Pleasant View Planning Commission

Meeting Agenda

Planning Commission Staff Report

Vista Lago – Pole Patch II #28 Single-Family Dwelling Conditional Use Permit and Site Plan

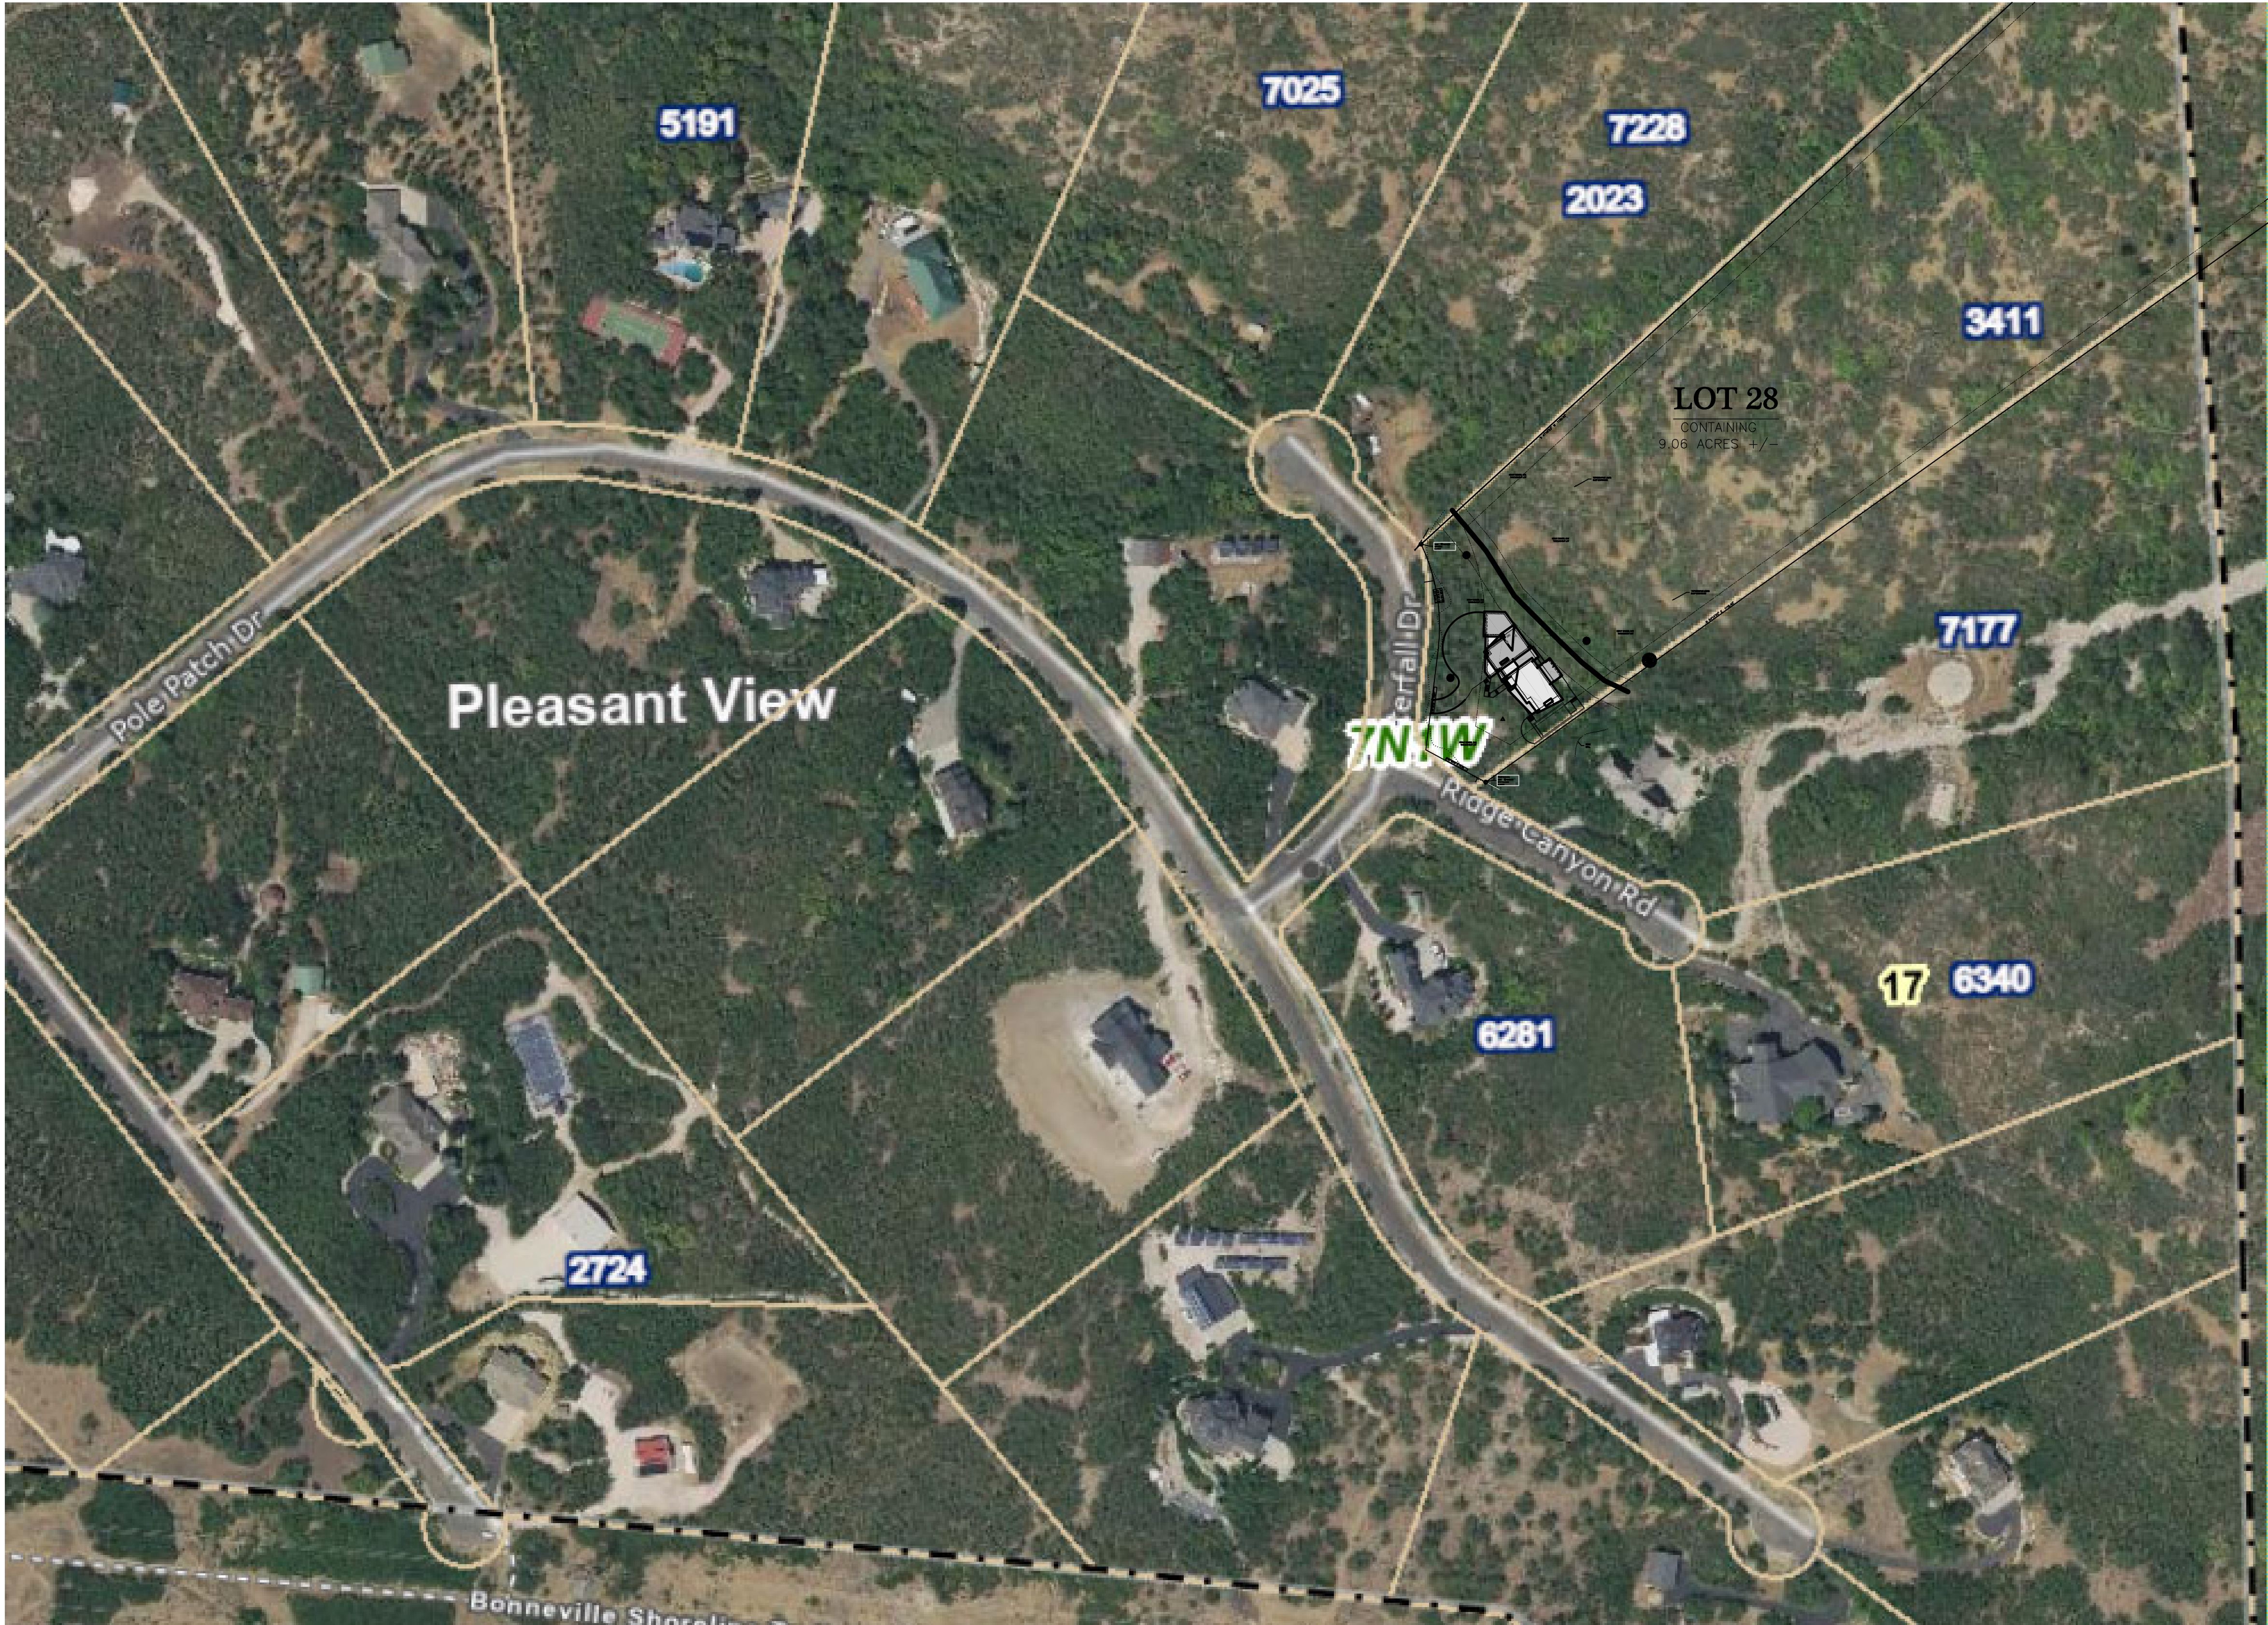
City Code 18.38.070.G – Structures shall not be placed on or across a fault nor within fifty feet unless it is determined by professional experts that the distance of fifty feet may be reduced without creating a potential hazard.

NOTE: THIS AREA IS IN DRINKING WATER SOURCE PROTECTION FOR SOME OF THE CITY’S WELLS & SPRINGS. NOTICE TO THE PROPERTY OWNER SHOULD BE GIVIN REGARDING POTENTIAL CONTAMINANTS & PRECAUTIONARY MEASURES TO TAKE.

NOTE: THIS AREA IS IN CRITICAL WATER RECHARGE ZONE. IMPERVIOUS AREA SHOULD BE KEPT TO A MINIMUM

Update: received Geotechnical/Geologic Report on 11/01/2022; 20.7’ setback from fault line recommended by Geologist met; distance appears to be met

MAP
3

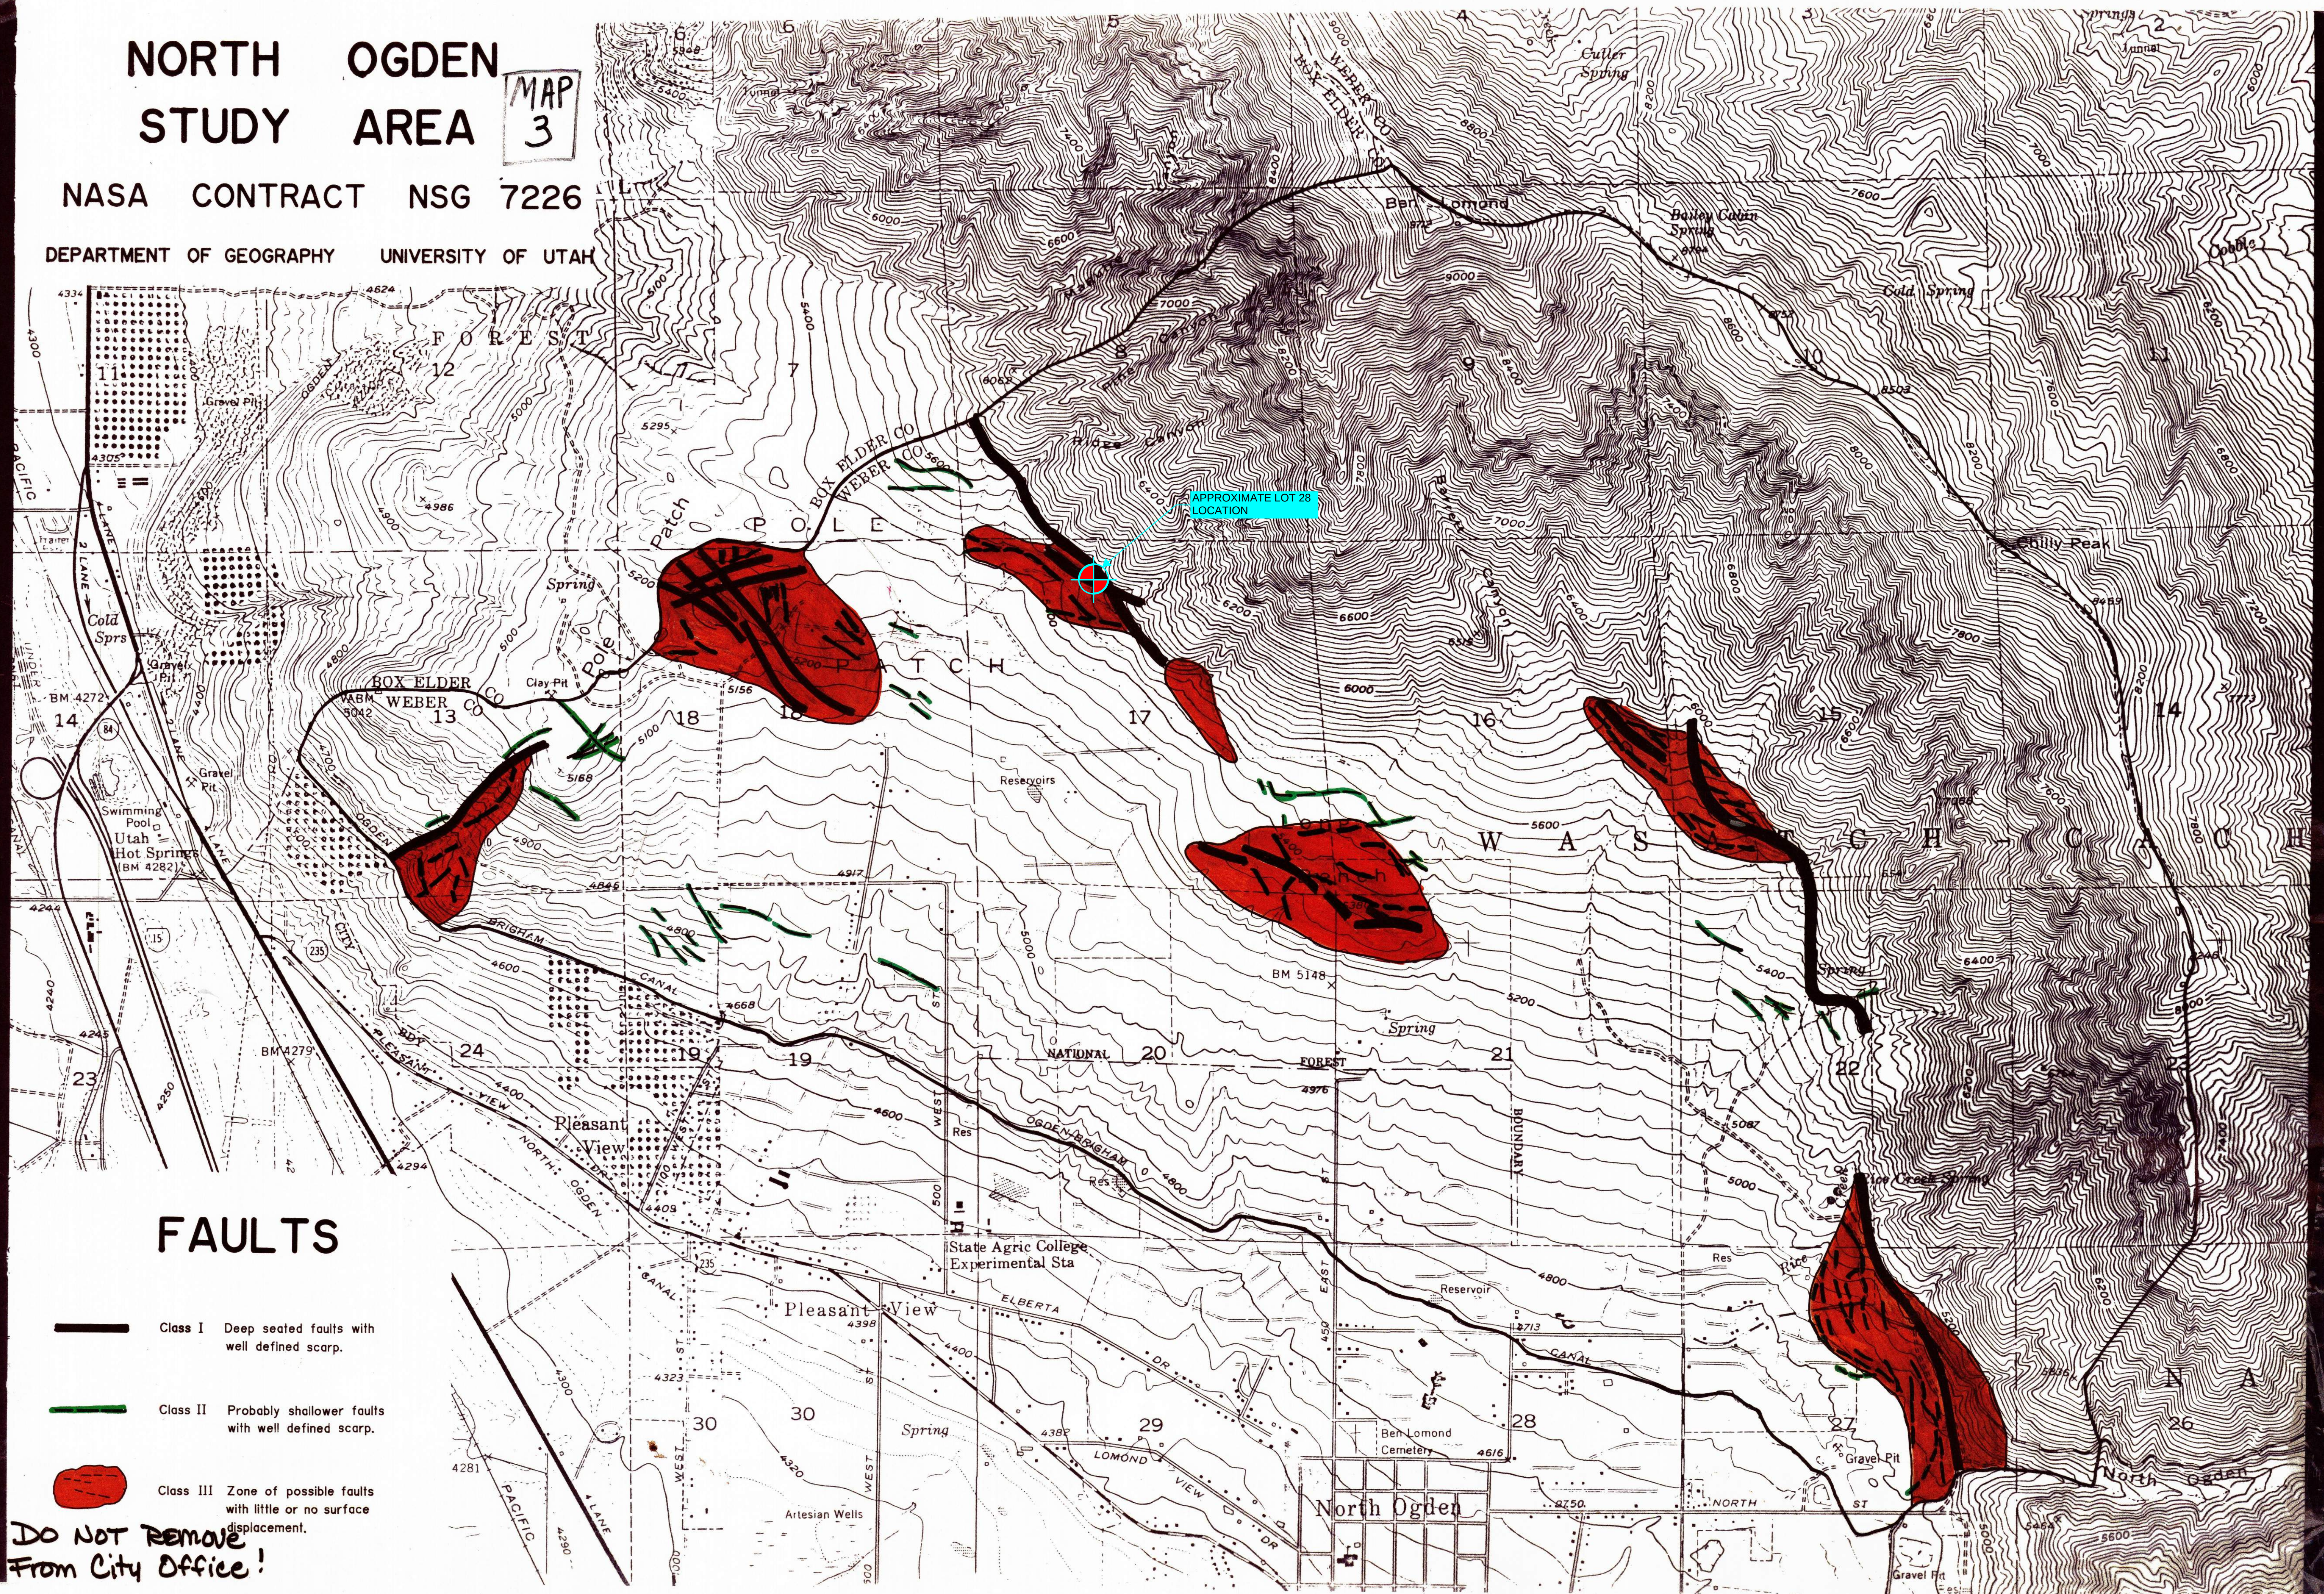
Staff Comment: This area has been determined to be within a sensitive lands area, based on being within a proximity to an earthquake fault, as demonstrated on NASA Map 3 (See Exhibit C). The applicant has provided a geotechnical report A geotechnical report prepared by geotechnical and engineering professionals at Christensen Geotechnical, has recommended that the needed distances from the fault is 20.7 feet on the south/west side of the fault (see Exhibit D, page 7-8), thus superseding the 50’ requirement.

Staff Comment: This property has been determined to be within the Sensitive Land Overlay Zone, based on Earthquake Fault ‘Map 3’ (See Exhibit D). A single-family home in this area, which would otherwise be permitted use, is required to be considered for a conditional use permit, per this section of the ordinance.
